**SENIOR CENTER
15 LOUIS LANE
COLCHESTER, CT 06415
BID #2022-013**

S/P+A PROJECT #20.003

DATE: October 6, 2022

The following changes to the Drawings and Project Specifications shall become a part of the Drawings and Project Specifications; superseding previously issued Drawings and Project Specifications to the extent modified by Addendum #2.

Revision:	Description:	Date:	Revised By:
Δ	ISSUED FOR BID	09/09/2022	
	ADDENDUM 2	10/06/2022

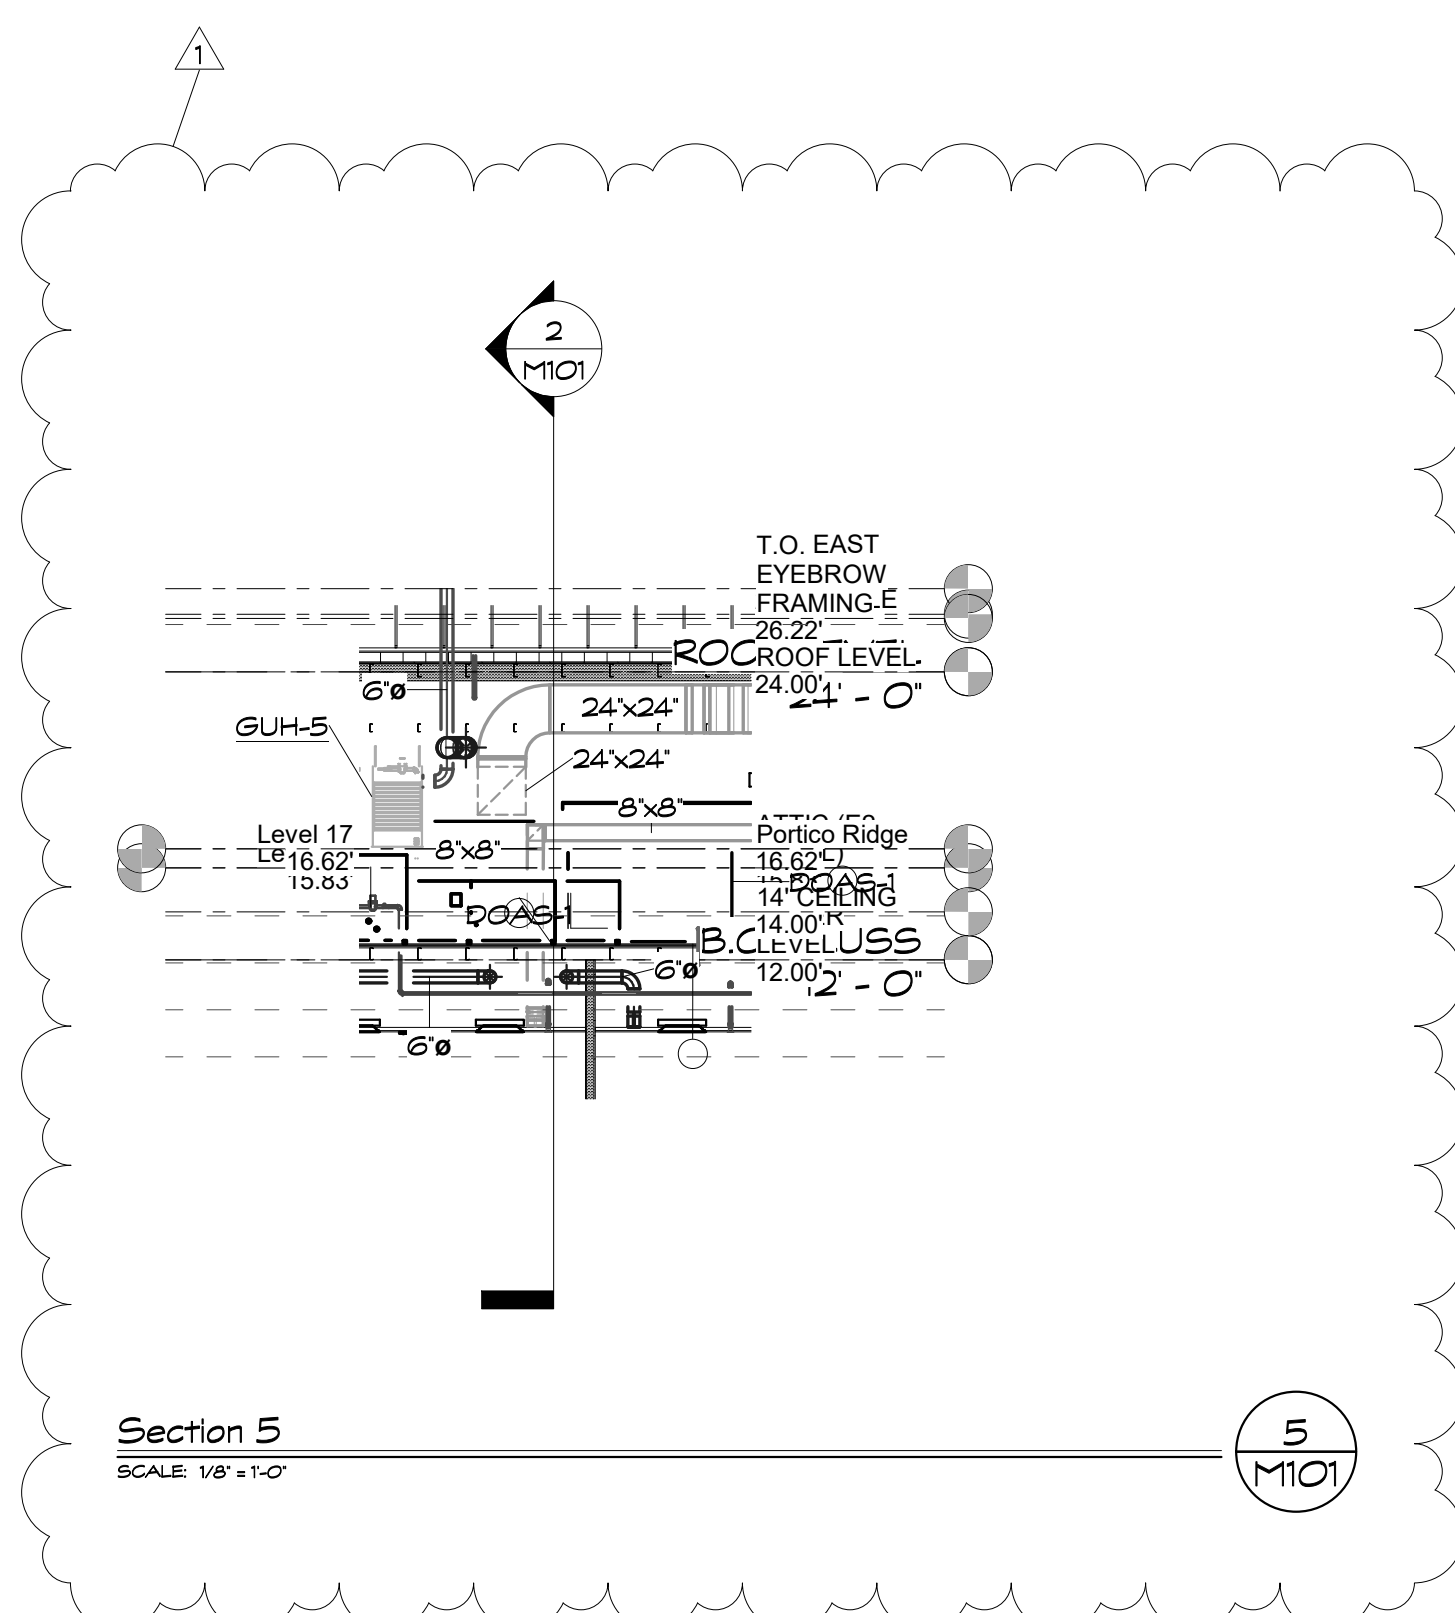
006	Please provide detailed ductwork information around the DOAS unit.	09/20/22	Refer to Addendum #2 for revised Drawings.	2
007	Is there any possibility that the bid date would be extended?	09/20/22	Bid date has been extended. Refer to Addendum #1.	1
008	Regarding the window treatments, the specs call for shades with a front fascia, but detail 2/A550 shows a recessed shade box. Details 7/A550 and 1/A552 also show a shade box below the ceiling. Please clarify if all shades are to receive front fascia only, or if some will be requiring shade pocket (recessed or surface mounted).	09/21/22	Window treatments are to have a front & back fascia (also referred to as a headbox). This headbox is to be installed exposed and recessed as indicated in the Drawings. Refer to Addendum #1.	1
009	Can the bid be extended 1 week?	09/21/22	Refer to RFI #007.	1
010	Are lockers included in this project? If so, please provide specs.	09/21/22	No.	1

- DRAWING M502, MECHANICAL DETAILS has been added and is attached as part of this addendum.*

1 MAIN LEVEL POWER PLAN

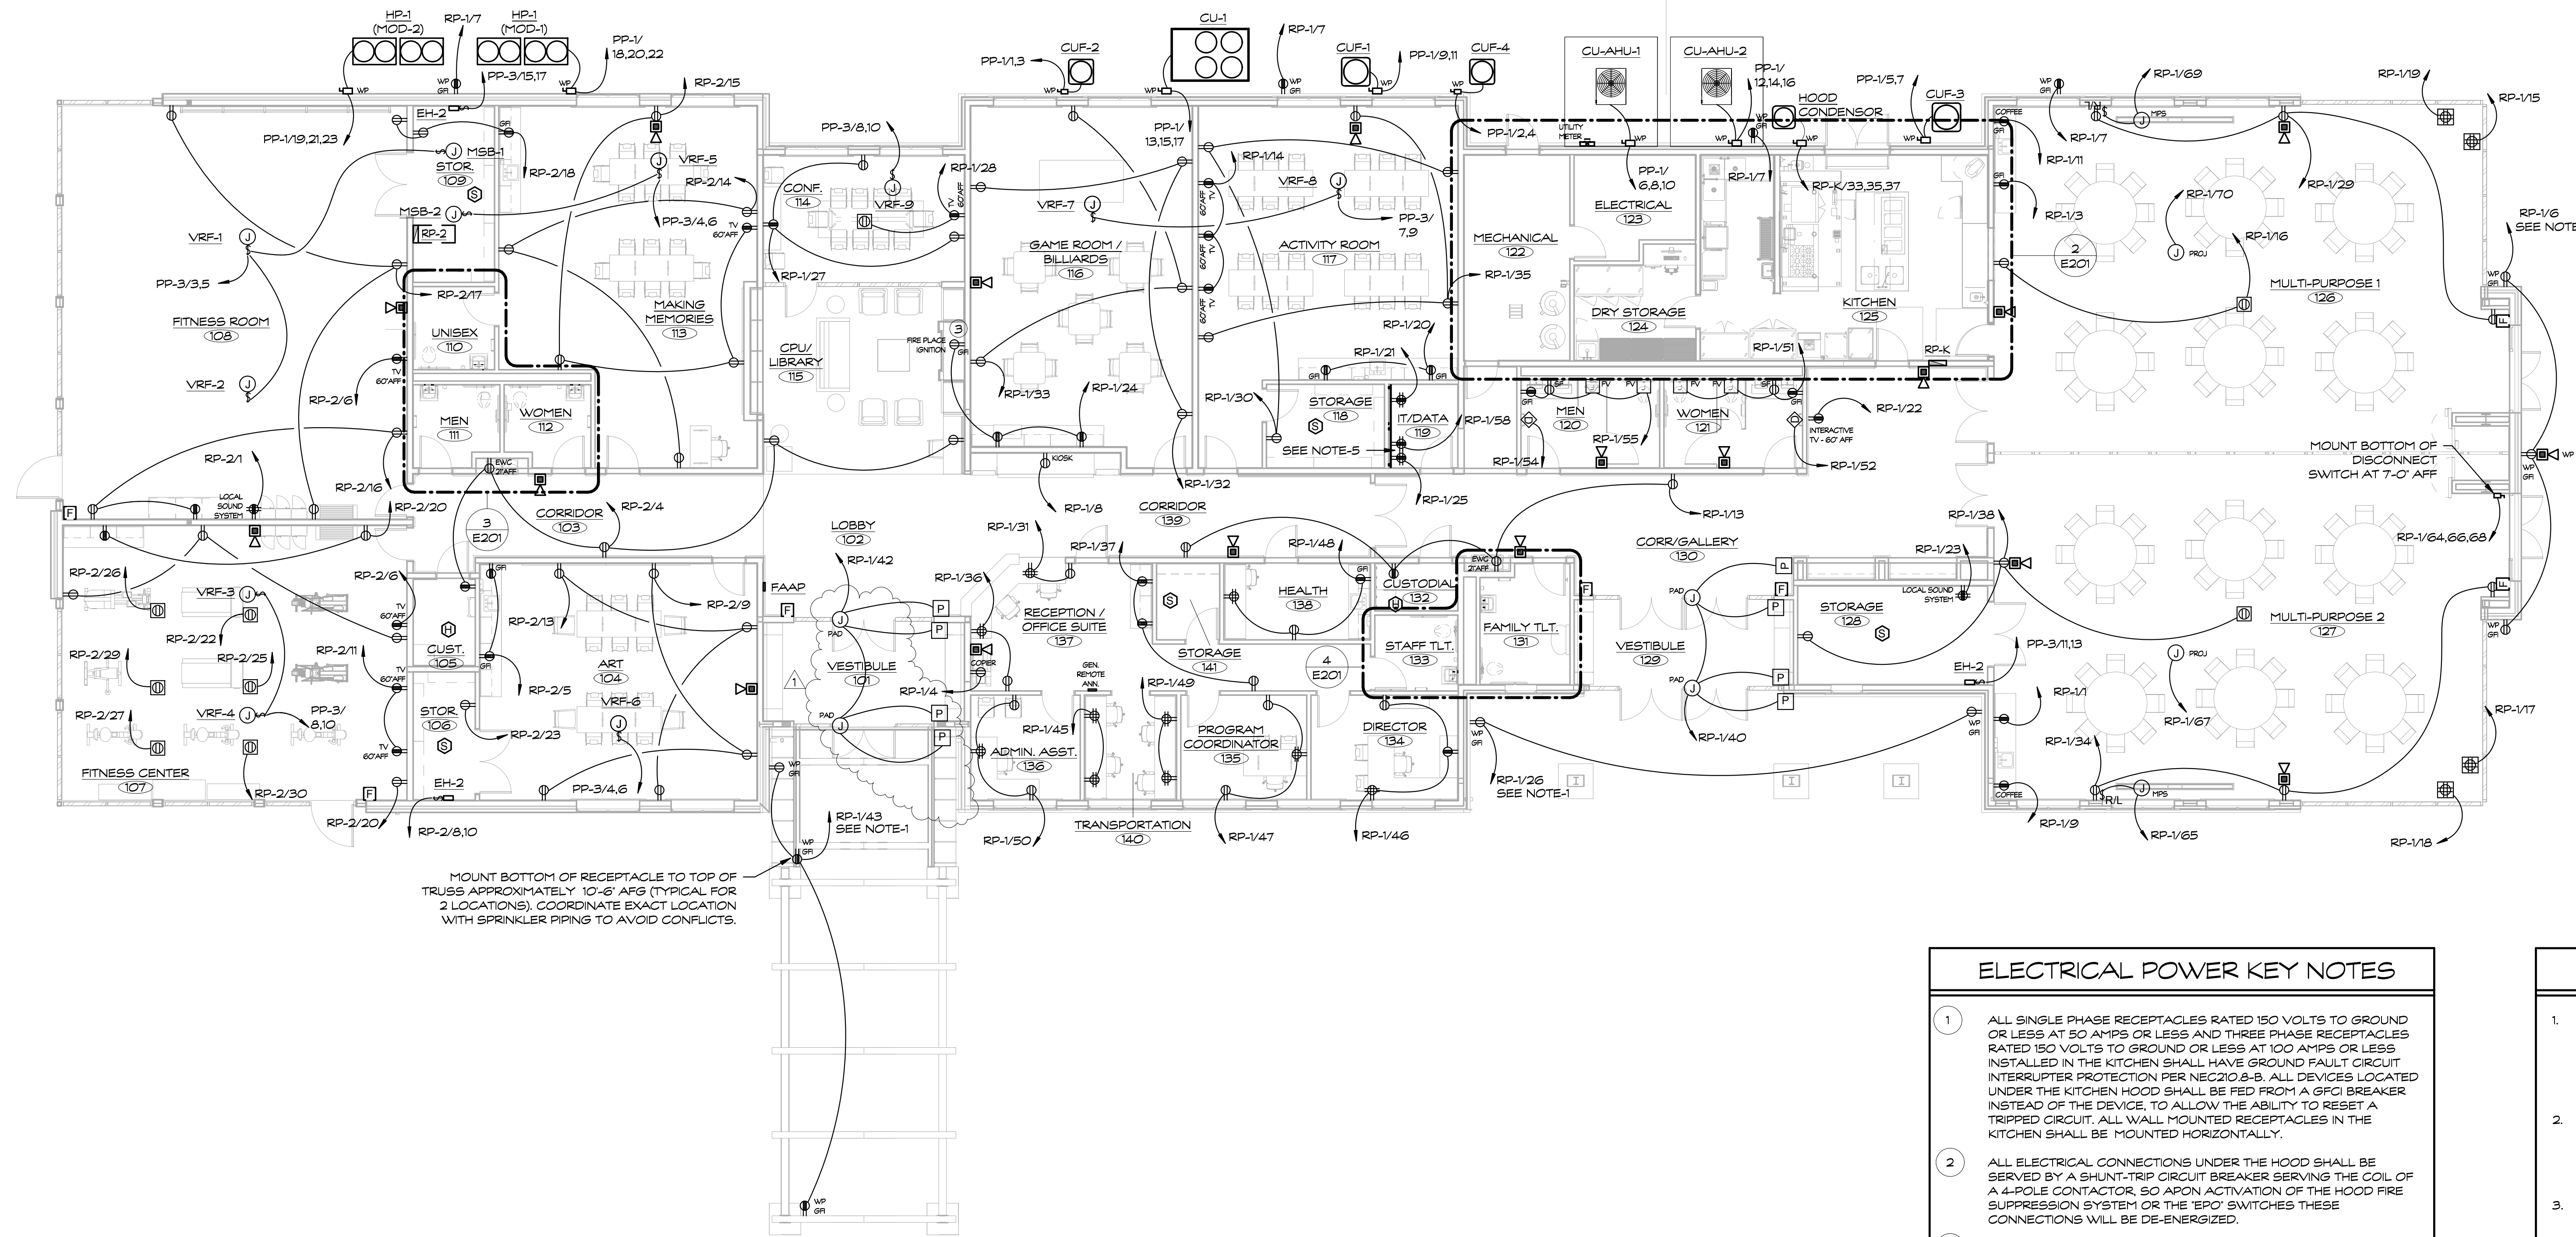
MOUNT BOTTOM OF RECEPTACLE TO TOP OF TRUSS APPROXIMATELY 10'-6" AFS (TYPICAL FOR 2 LOCATIONS). COORDINATE EXACT LOCATION WITH SPRINKLER PIPING TO AVOID CONFLICTS.
